INDIANA DEPARTMENT OF TRANSPORTATION

STANDARDS COMMITTEE MEETING AGENDA

RE: Agenda for the February 21, 2008 Standards Committee Meeting

INDIANA DEPARTMENT OF TRANSPORTATION	
RAILROAD CROSSING DETAILS	
PCC HEADER	
SEPTEMBER XXXX	
STANDARD DRAWING NO. E 614-RRGC-02	DATE
DESIGN STANDARD ENGINEER	DATE
CHIEF HIGHWAY ENGINEER	DATE
PROJECT NO. 9750	STATIONING
NO. 9750	STATIONING
PROJECT NO. 9750	STATIONING

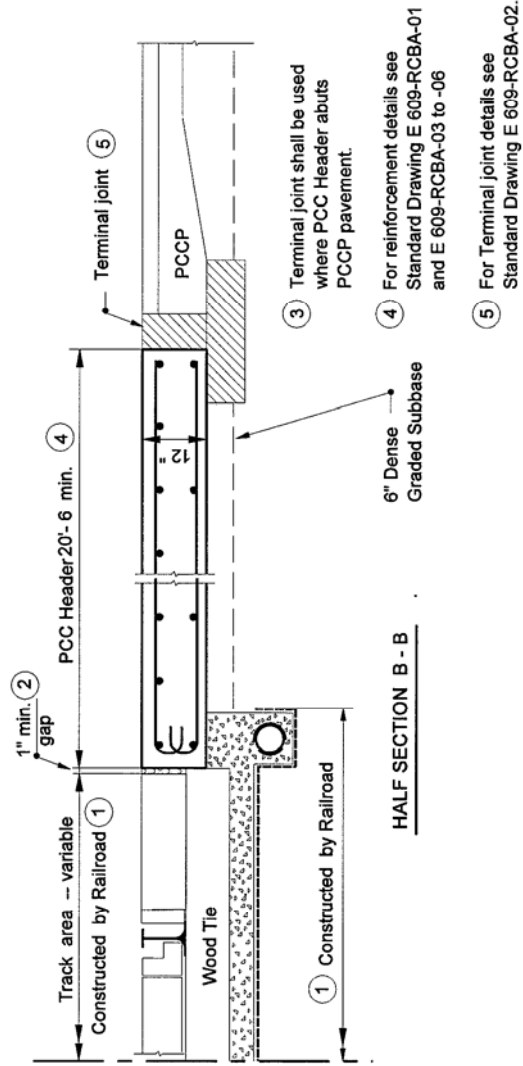
- NOTES :**
- Construction between headers to be executed by the railroad company in accordance with details as provided for in the crossing agreement.
 - 1 in. min. joint filler

INDIANA DEPARTMENT OF TRANSPORTATION	
RAILROAD CROSSING DETAILS	
CROWN-OUT DIAGRAM	
SEPTEMBER 200X	
STANDARD DRAWING NO. E 614-RRGC-05	
DESIGNED BY	DATE
CHECKED BY	DATE
IN CHARGE	DATE

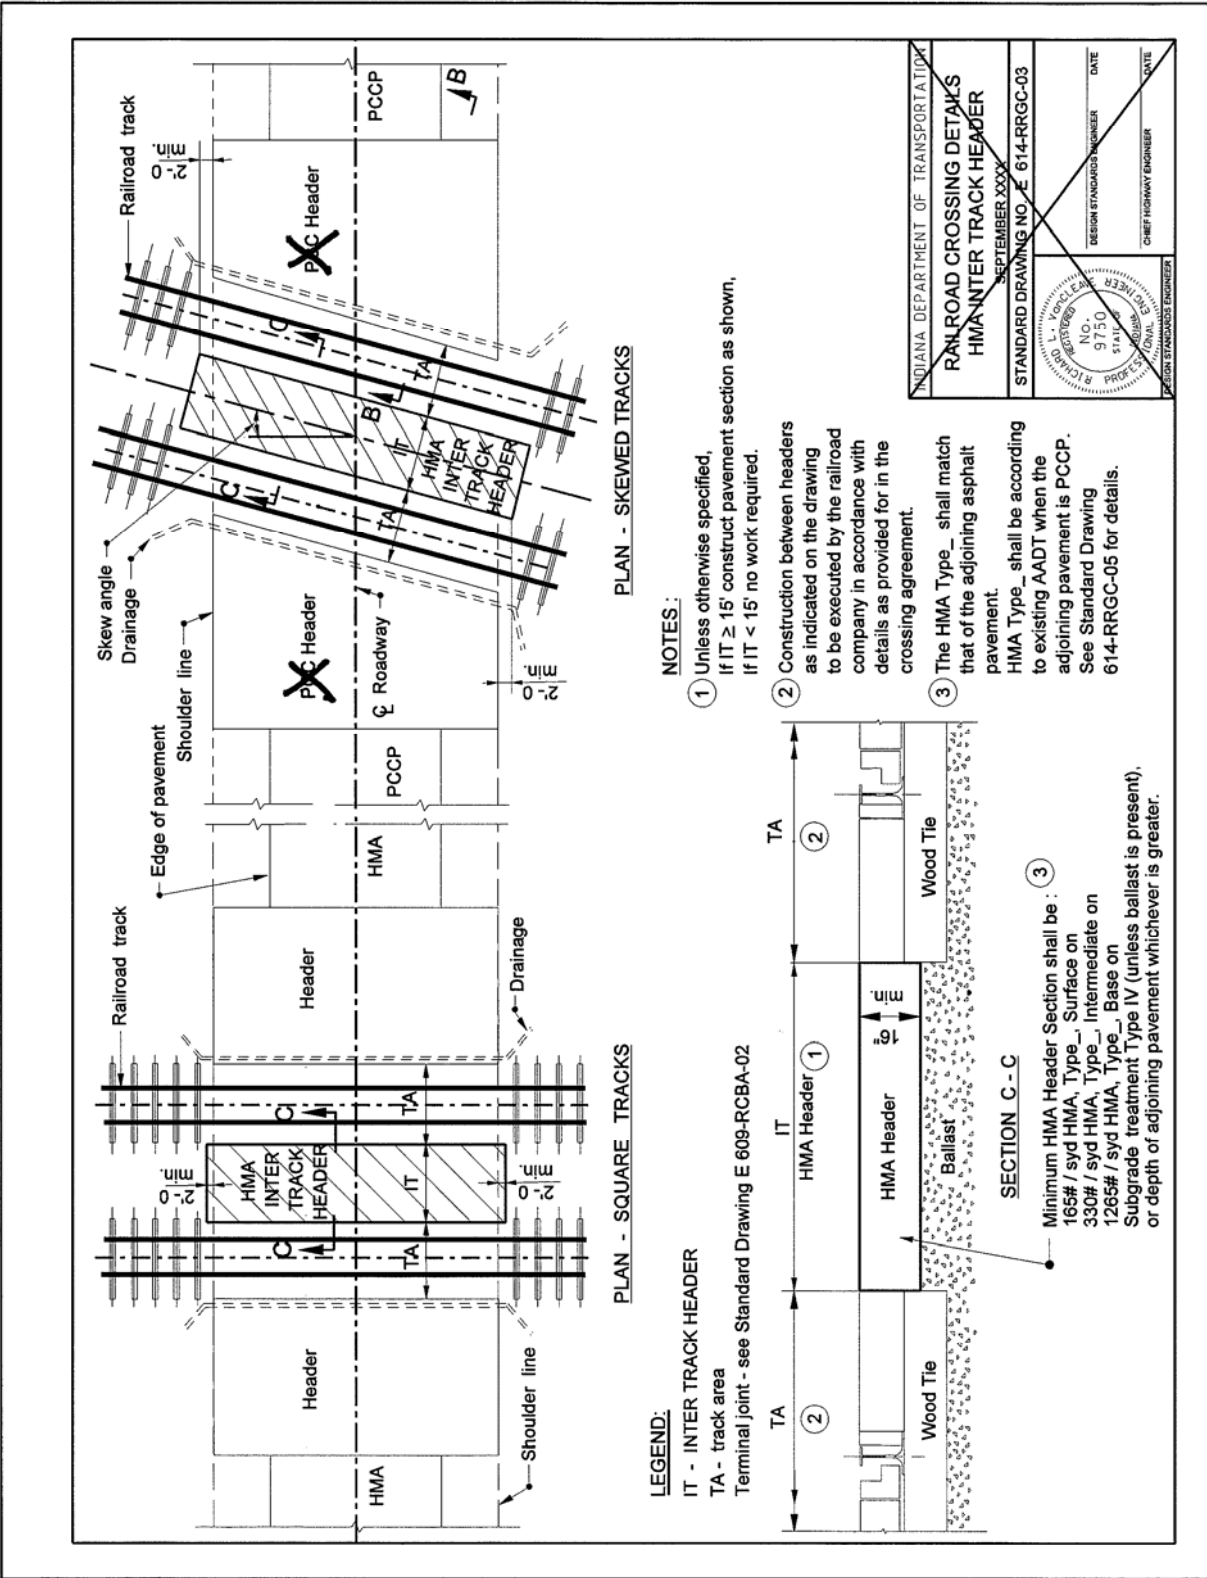
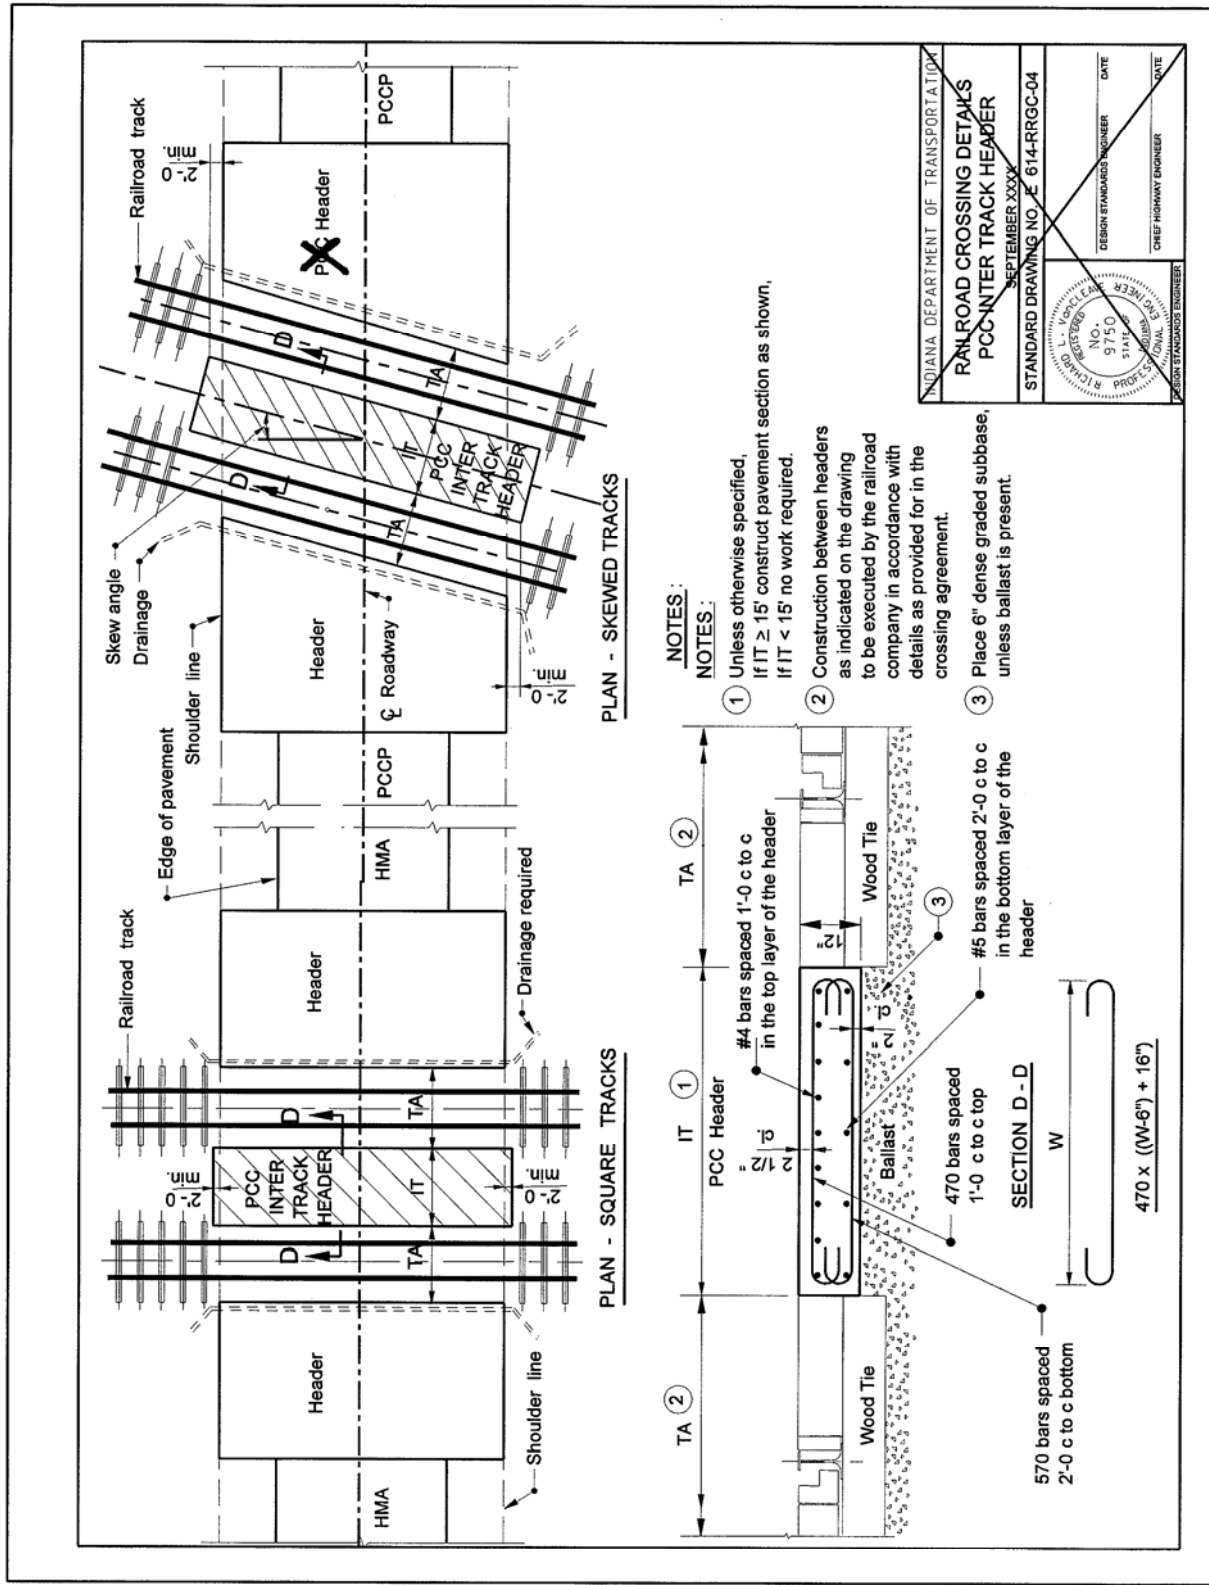
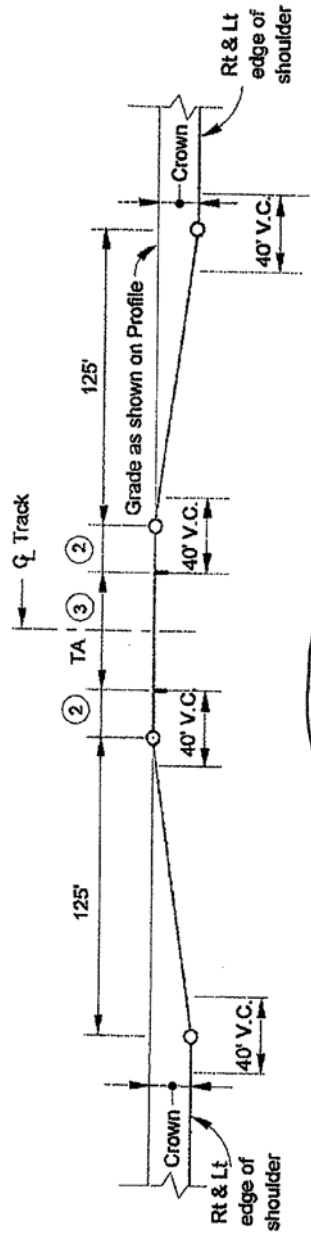
PROBLEM(S) ENCOUNTERED: Need Standardized Railroad Headers

PROPOSED SOLUTION: create and approve standard drawings

614-RRGC-01, Railroad Crossing Details, HMA Header
614-RRGC-02, Railroad Crossing Details, RC Header
614-RRGC-03, Railroad Crossing Details, HMA Inter-Track Header
614-RRGC-04, Railroad Crossing Details, RC Inter-Track Header
614-RRGC-05, Railroad Crossing Details, Crown-Out Diagram

- ① Crown shall be taken out of pavement at each railroad crossing.
- ② 20 ft or as required due to track skew.
- ③ TA is a track area to be constructed by railroad company.

Construction-Year AADT	HMA Type
< 200	A
200 ≤ AADT < 2000	B
2000 ≤ AADT < 7000	C
≥ 7000	D

INDIANA DEPARTMENT OF TRANSPORTATION	
UNDERDRAIN DETAILS	
JANUARY 2000	
STANDARD DRAWING NO. E 718-UNDR-01	
	/s/ Anthony L. Urzavich REGISTERED PROFESSIONAL ENGINEER DATE: 1-03-00
/s/ Bruce Zandt CHIEF HIGHWAY ENGINEER DATE: 1-03-00

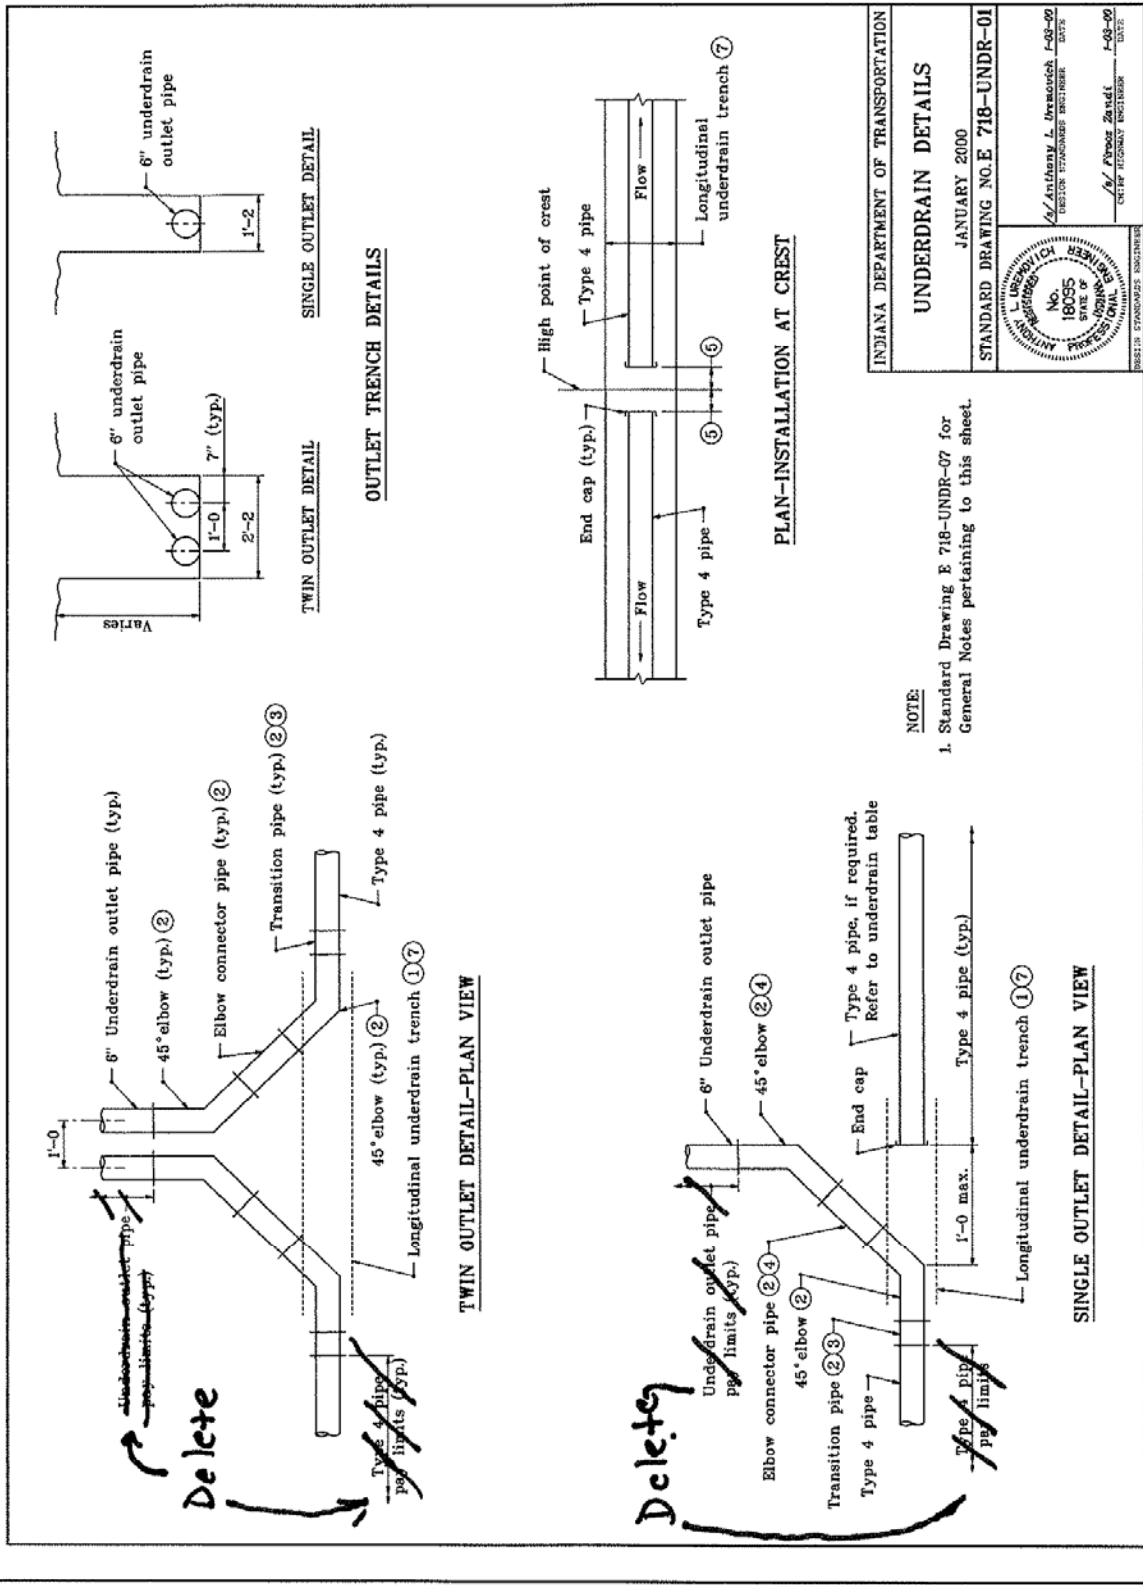
PROPOSED SOLUTION: Revise section 718 to clarify that elbows for underdrains will not be measured for payment. These changes will agree with pay limits detailed in Standard Drawing E 718-UNDR-01.

718-UNDR-01 Underdrain Details

NECK-DRAIN EXTENSION FOR
STEEL STRUCTURE
CONCRETE MEMBER
715-DEX-02

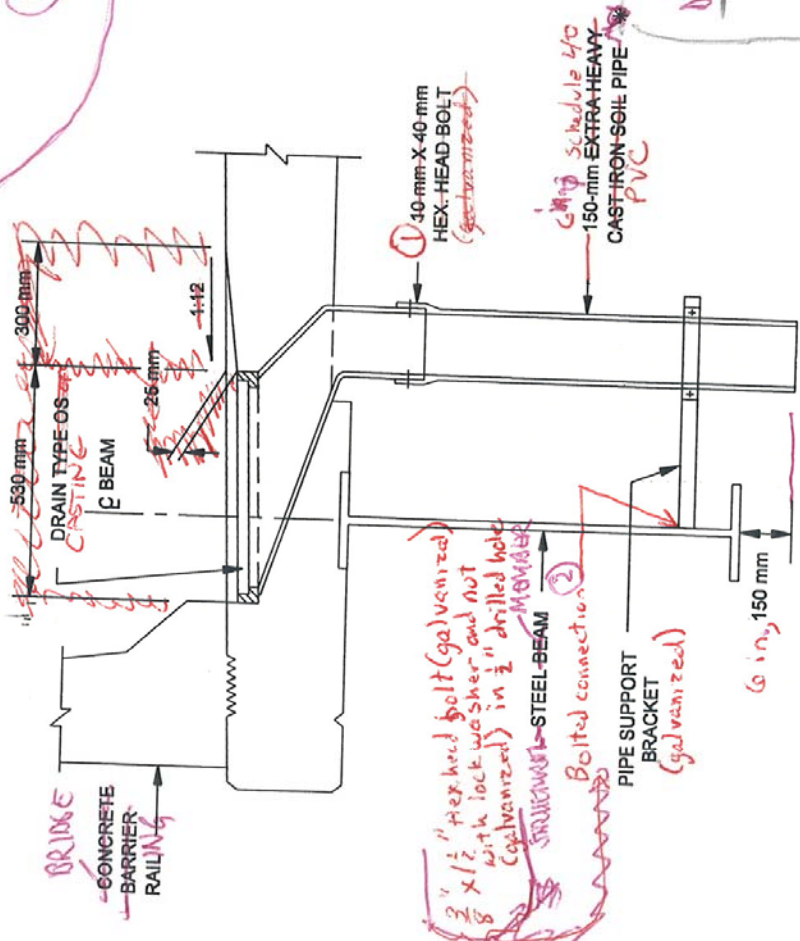
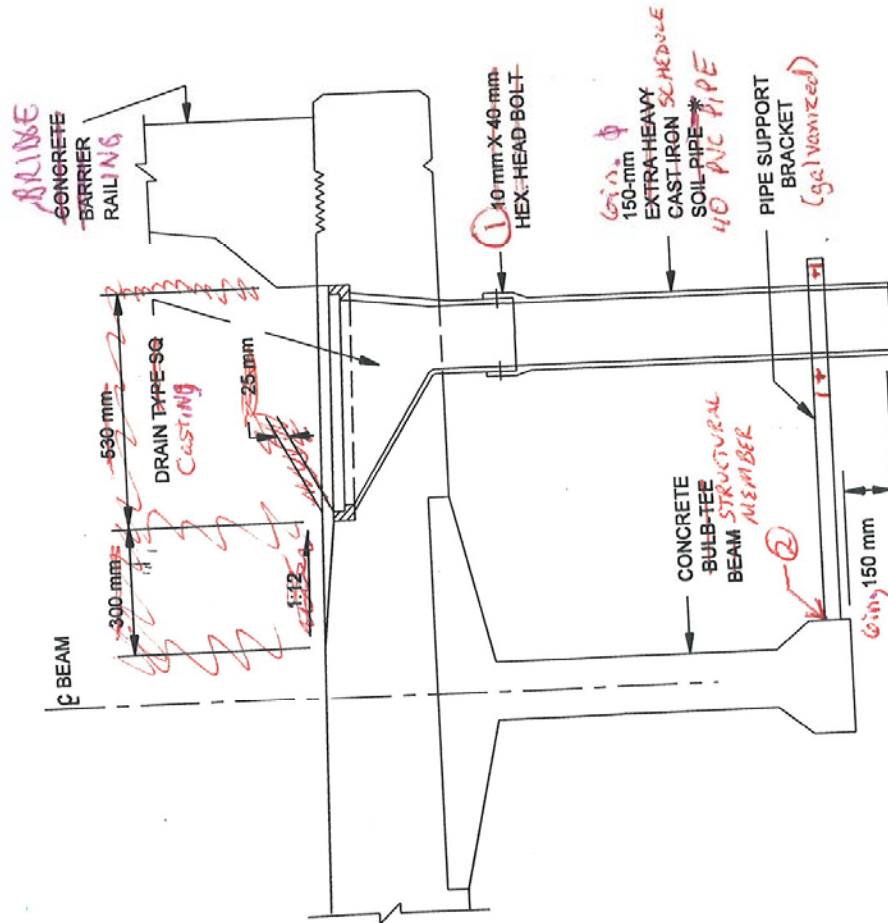
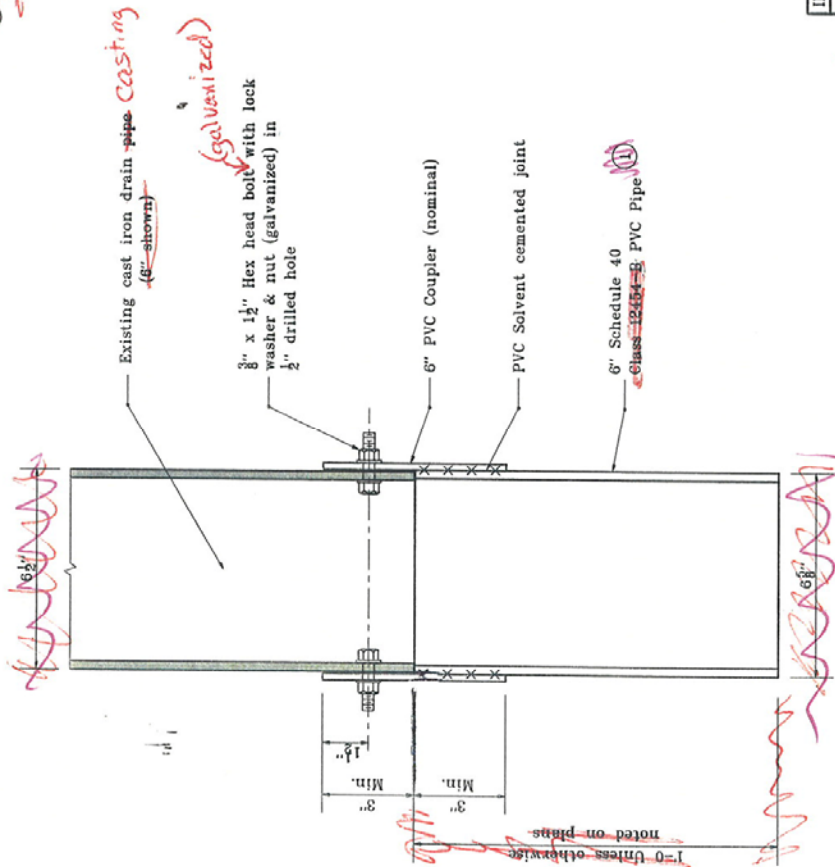
If a deck drain type SQ or OS discharges straight down, a drain extension should be specified. The drain-extension material is now PVC, and no longer cast iron. New standard drawings 715-DDEX-01 thru -03 show the details of the drain extension. Cast-iron soil pipe should still be used where the deck-drain system is extensive.

① See 715-DEX-03 for Standard Drawing connection details.

② Anchor to concrete structural member using an approved galvanized anchor system.

① Class 12454-B is an updated ASTM designation for Type I-Grade I PVC pipe.
